## **I. Proposal for supplement 7 to the 03 series of amendments to UN Regulation No.51 (Noise of M and N categories of vehicles)**

Annex 3 – Appendix, amend to read:

Figure 3b

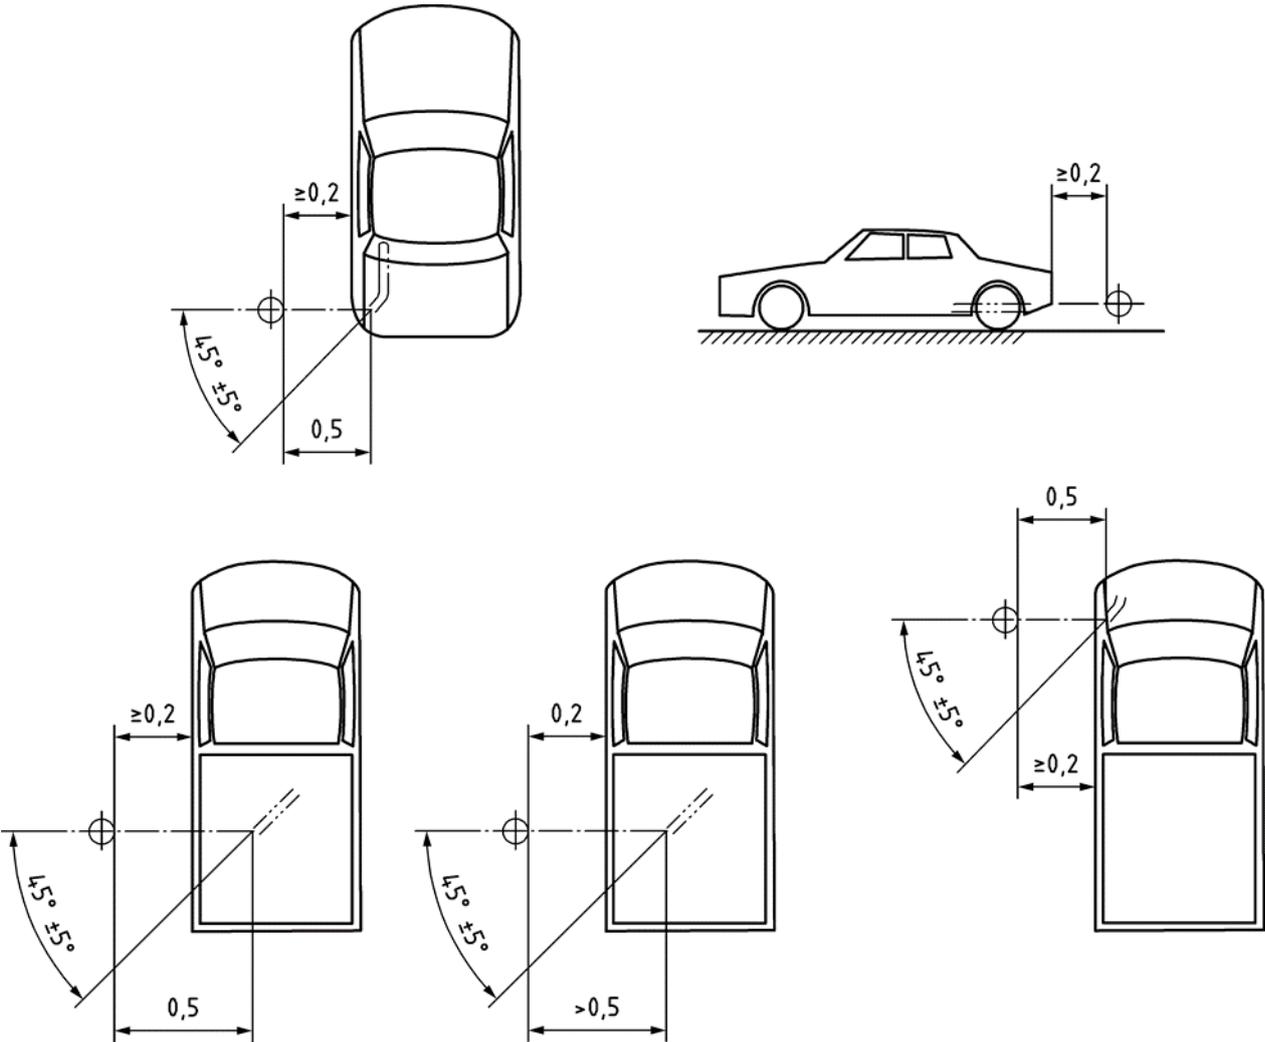
**For vehicles, where the reference point of the exhaust pipe is not accessible, or located under the vehicle body, as shown in Figure 3b and 3c in Annex 3, because of the presence of obstacles which form part of the vehicle (e.g. spare wheel, fuel tank, battery compartment), the microphone shall be located at least 0.2 m from the nearest obstacle, including the vehicle body, and shall not be located under the vehicle. Its axis of maximum sensitivity shall face the exhaust outlet from the position least concealed by the above mentioned obstacles. In case the distance from the exhaust outlet to the other side of the vehicle is larger than 0.2 m (Figures 3c and 3d in Annex 3), the following distances of  $d_1$  and  $d_2$  shall be chosen:**

Figures 3b to 3d have been updated in according to the latest revision of ISO 5130:2019.

Figure 3c

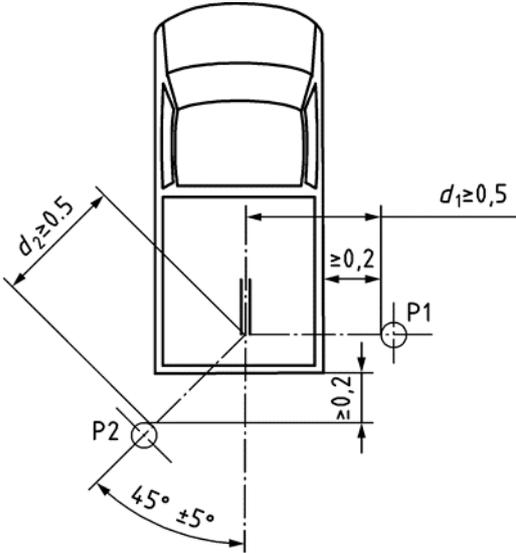
When several positions are possible, as shown in Figure 3c, the microphone position giving the lowest value of  $d_1$  or  $d_2$  shall be used.
